**Final decision on Transpower's application to amend the project outputs and major capex allowance for Upper South Island reliability stage 1 project [2015] NZCC 4**

**Date of Decision:** 26 February 2015

**Figure C1: Observed demand, forecast and transmission limit for upper South Island**

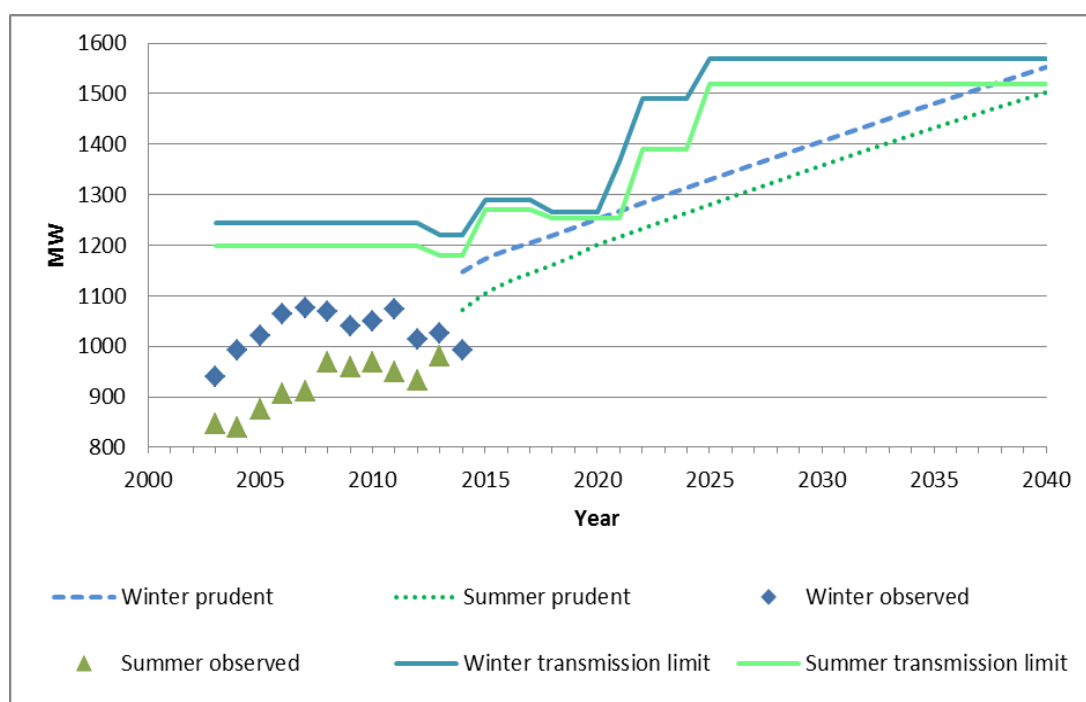
*Transpower's demand forecast seems to be optimistic*

C15 Figure C1: shows there is about 200 MW of margin between the current demand and the transmission limit.<sup>37</sup> For example the winter peak demands for the last three years have been around 1000 MW and the winter transmission limit is more than 1200 MW.<sup>38</sup>

Figure C3: Orari and Rangitata switching stations

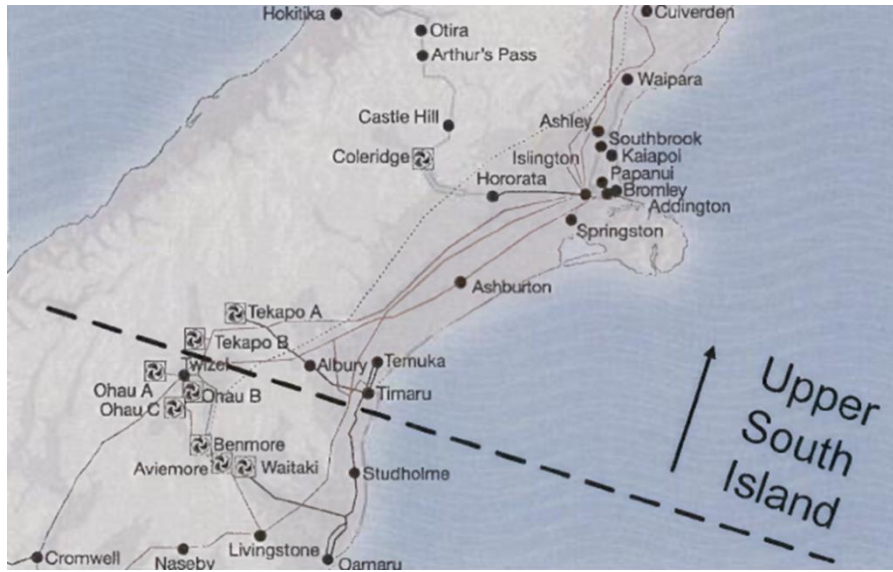
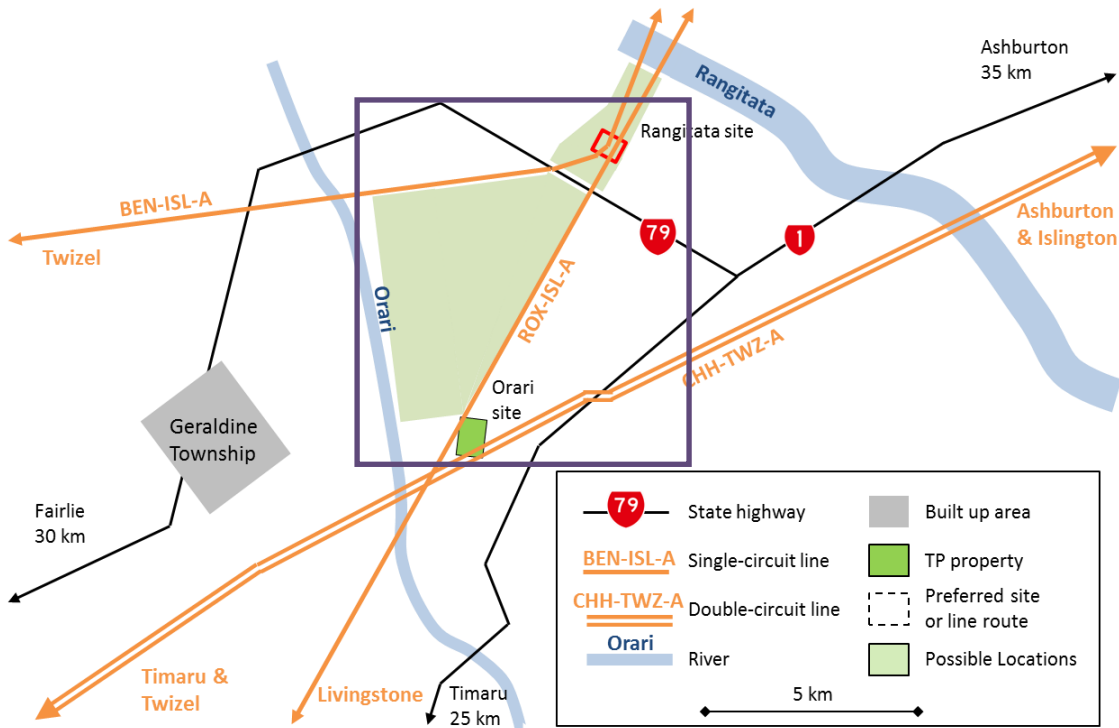
C32 Transpower owns the parcel of land identified as the 'Orari site' and plans to build one switching station at this site. Transpower will need to buy suitable land near the Rangitata River area for the second switching station.

D17 The proposed location of the northern site at Rangitata is directly below two existing transmission lines so it is unlikely that this would be affected by the installation of pivot irrigators, and there is already an irrigation pond in the vicinity. At Orari the switching station will be on land owned by Transpower so there are no land use change risks alterations to the existing lines will tend to be in the relatively narrow land areas between the existing transmission lines and the Transpower owned land so again pivot irrigators will be unlikely.

D18 We do accept that smaller scale irrigation schemes and irrigation ponds are possible on the Rangitata site and transmission line easements and there would be costs to remove or relocate them if they were constructed.
